PCO #003

Prime Contract Potential Change Order #003: PR 03 Precast and Roof Drain Updates (Labor)

PROPOSAL REQUEST 03 (PR-03)

PROPOSAL REQUEST 04 (PR-04)

B. Sheet M4-21

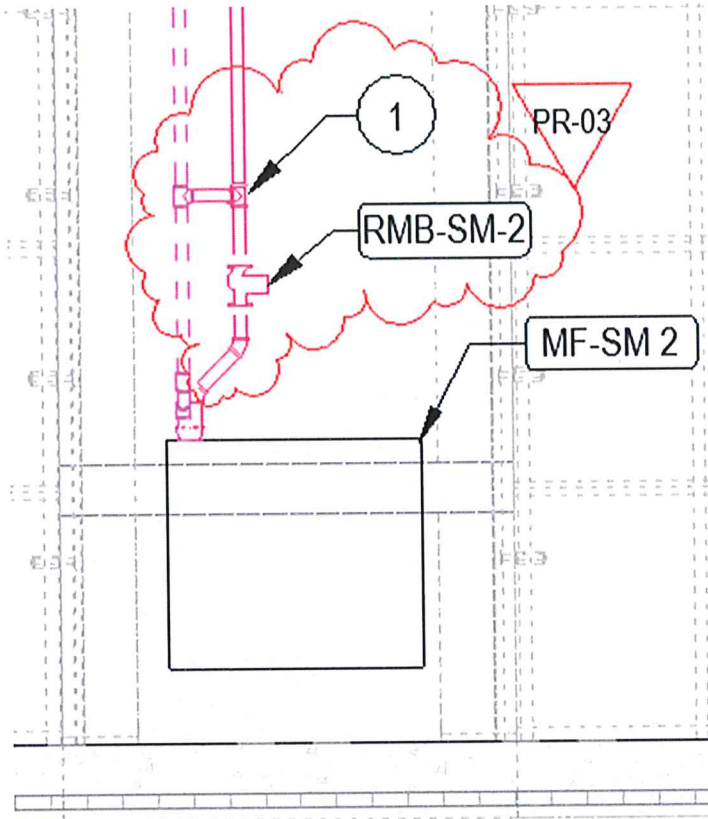
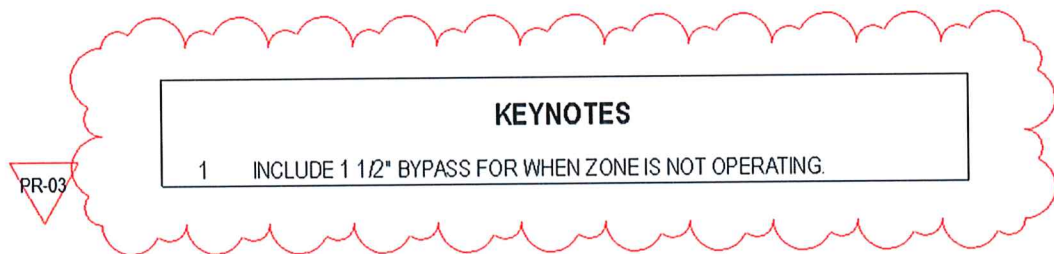
1. Added pump RMB-SM-1 and bypass piping. Both are typical for both RMB-SM-1 and for RMB-SM-2 (both snow melt zones).

2. Added keyed note for bypass piping.

A. Sheet M2-12

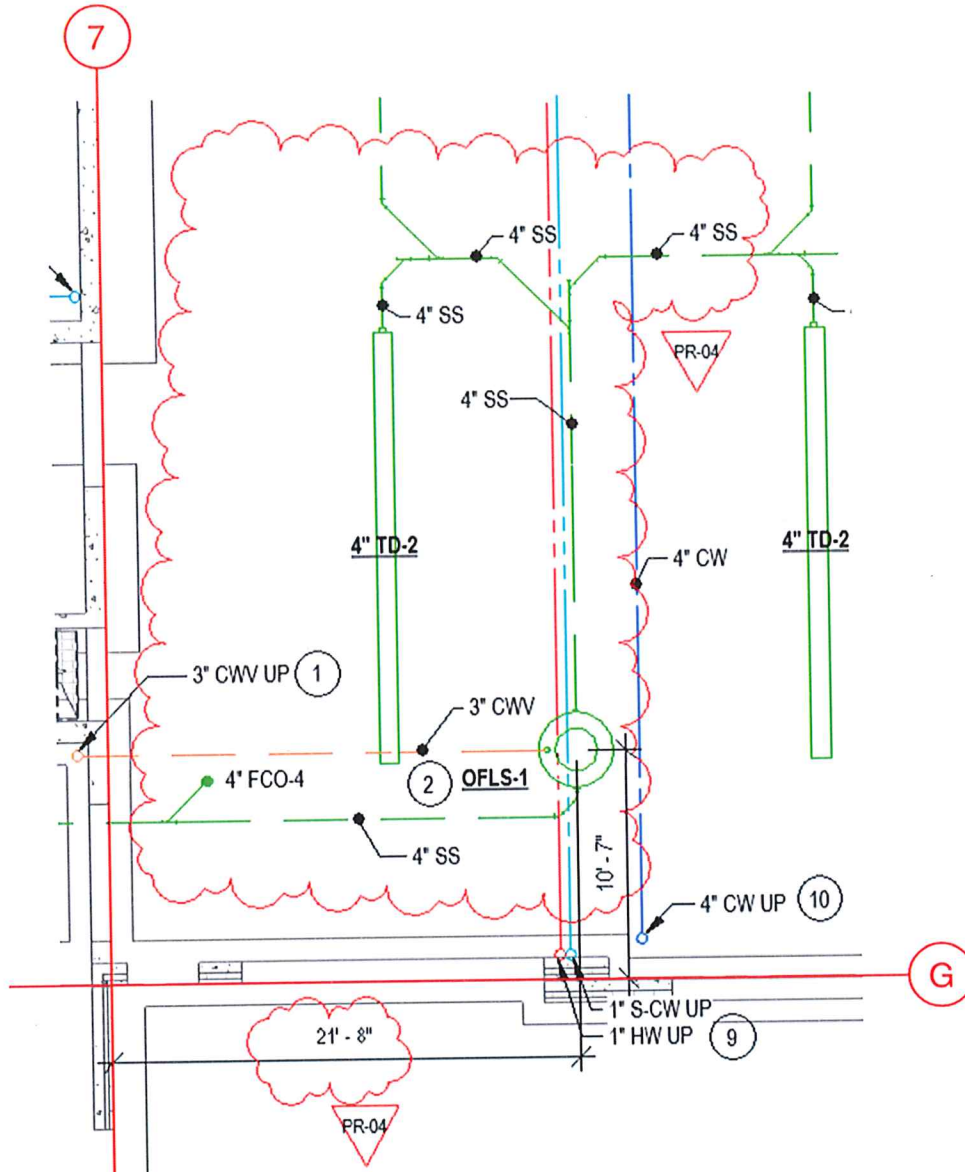
1. Provide credit for the omission all fire dampers (16 total) at wall penetrations into the following rooms: BUNK 217, BUNK 218, BUNK 219, BUNK 220, BUNK 221, BUNK 222

C. Sheet P2-10

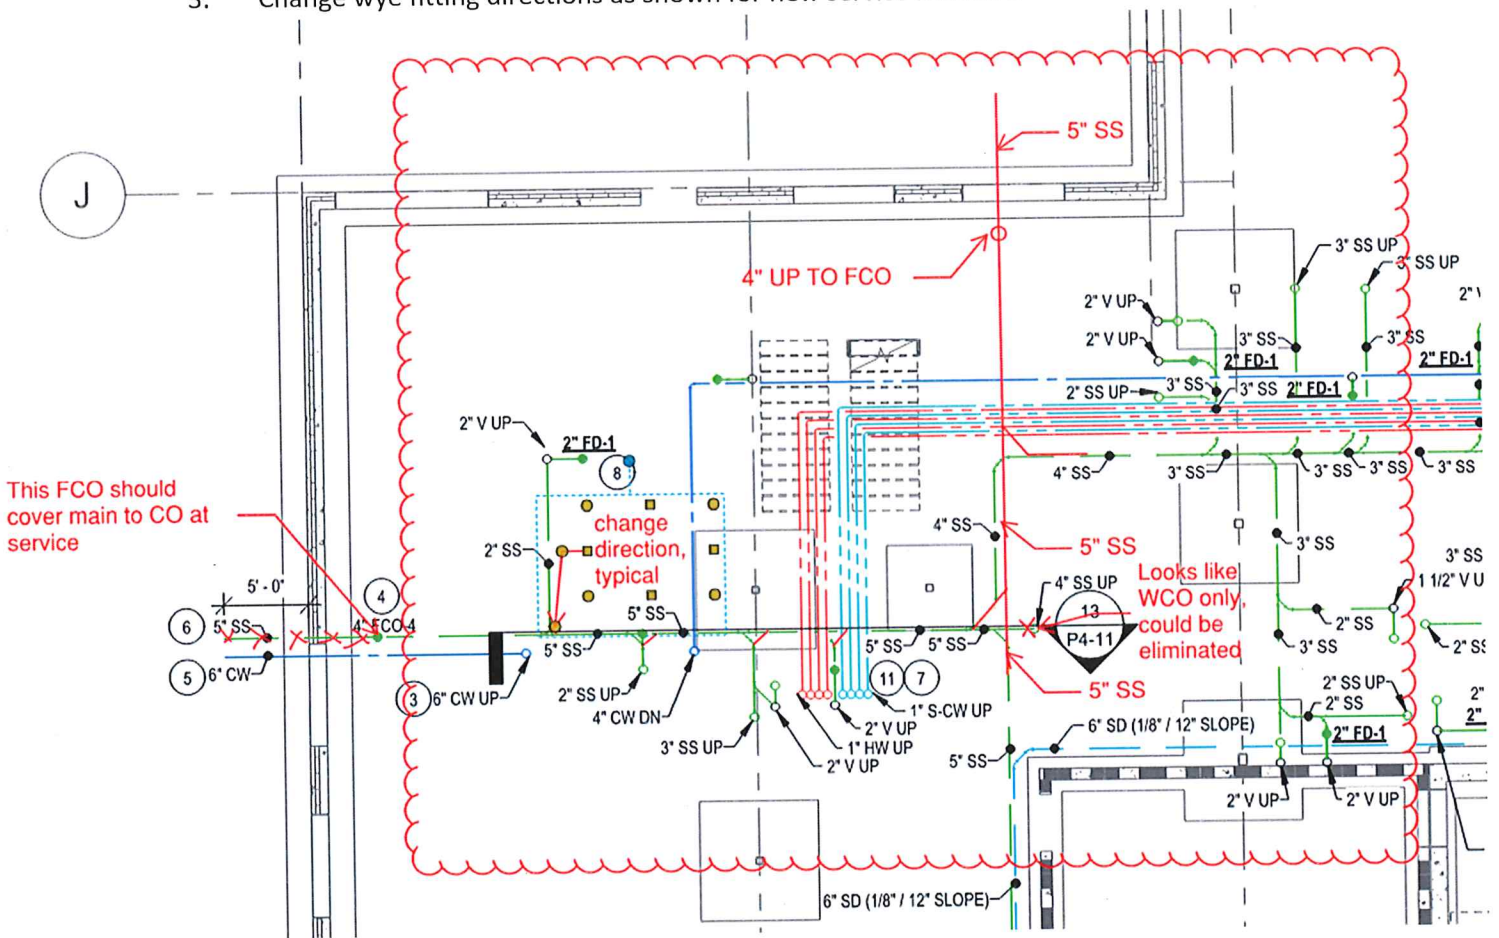
- Sanitary sewer service shall leave the building to the East below VEST 152 instead of originally shown under GENERATOR 155. Add 5" Sanitary Sewer main piping East as shown. Add 4" SS piping up to FCO-4 before exiting the building foundation. Revise section of 4" SS piping running East-West under CORRIDOR 126 to be 5".
- Omit 4" SS piping up to WCO in CORRIDOR 126. Omit all sanitary piping South of 4" FCO-4 in CITY ADMIN 123.
- Change wye fitting directions as shown for new service location.
